## Section 75W to Concept Plan (MP10\_0003)

### Discovery Point, Wolli Creek

Submitted to Department of Planning and Infrastructure  
On Behalf of Discovery Point Pty Ltd and Discovery Point Devt Pty Ltd

June 2013 ■ 13066

**Figure 2** – Illustration of re-distribution of floor space across Stage 8 -10

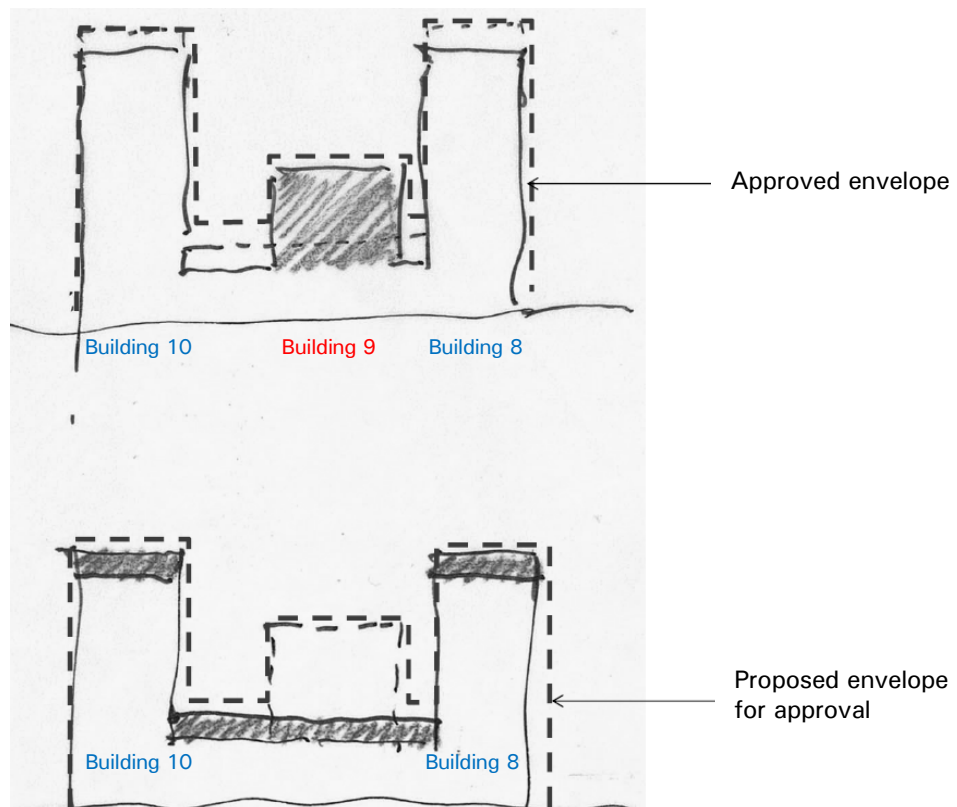
After PTW's appointment and following the further testing and analysis of the approved building envelopes, it became clear that a superior design and amenity outcome could be delivered on the site through the redistribution of floor space and volume from what was originally proposed under the Concept Plan for the site. **Figure 2** illustrates diagrammatically how this is able to be achieved. In short, Building 9 is no longer proposed to be developed in its totality and the residual floor space is proposed to be placed at the upper levels of Buildings 8 and 10.

**Figure 3** – New opening between Buildings 8 and 10

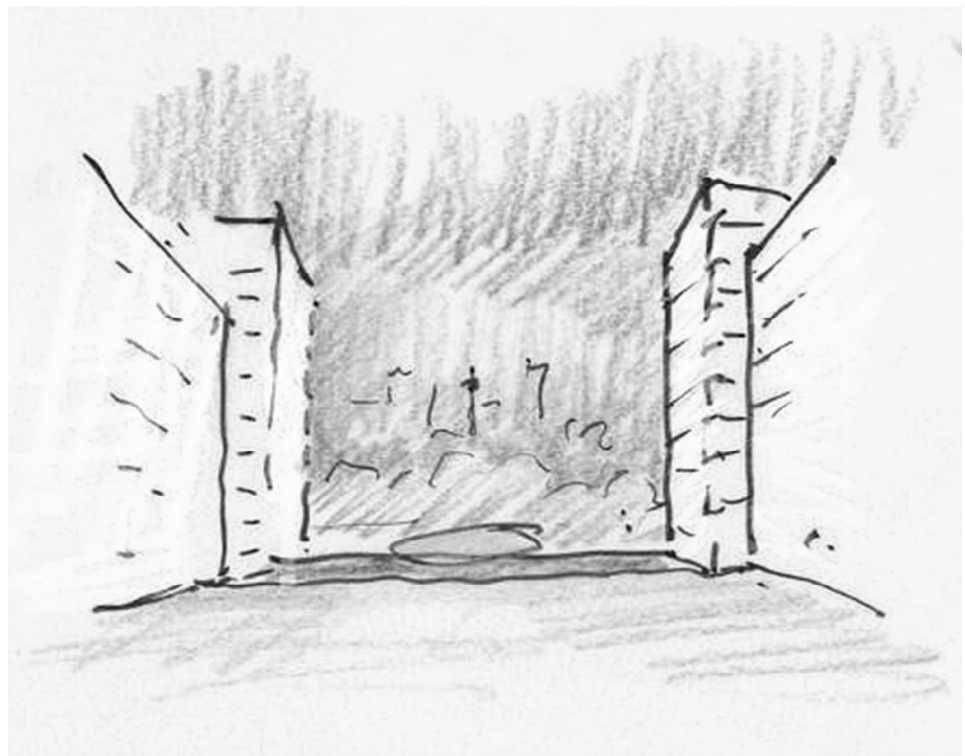
The proposed modifications to the Buildings 8, 9 and 10 envelopes will result in an improved built form over the Discovery Point site. The removal of the tower element of Building 9 will open the clustered built form of Stages 8-10, providing further interest in the built form through a greater varying of scale. **Figure 3** illustrates the new opening to be provided between Buildings 8 and 10.

The inclusion of the minor 1.7m increase in height on Buildings 8 and 10 is proposed to accommodate lift overruns and services. These essential building elements will be positioned so as to not be visible from the street or significant public domain areas such as along the Cooks River foreshore and Discovery Point Park.

**Figure 5** – Limitation of views in current design

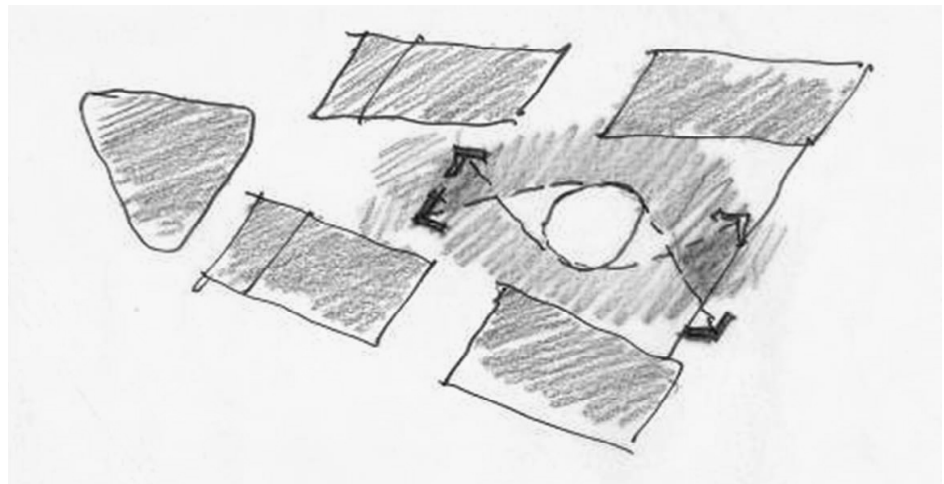
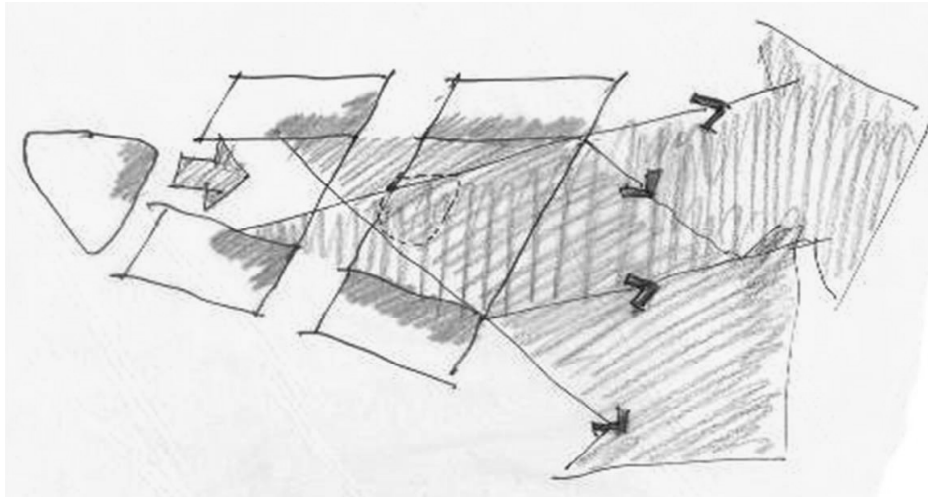
In its current form, Building 9 significantly limits views from future Buildings 11, 12 and 13. Through a more detailed review of the northern precinct of Discovery Point it has been identified that a strong and attractive vista could be created through removing this infill tower form. **Figure 5** below illustrates the constraint of the current infill Building 9 tower. **Figure 6** on the other hand, illustrates the opportunity available to create a vista, benefitting a wider range of future residents.
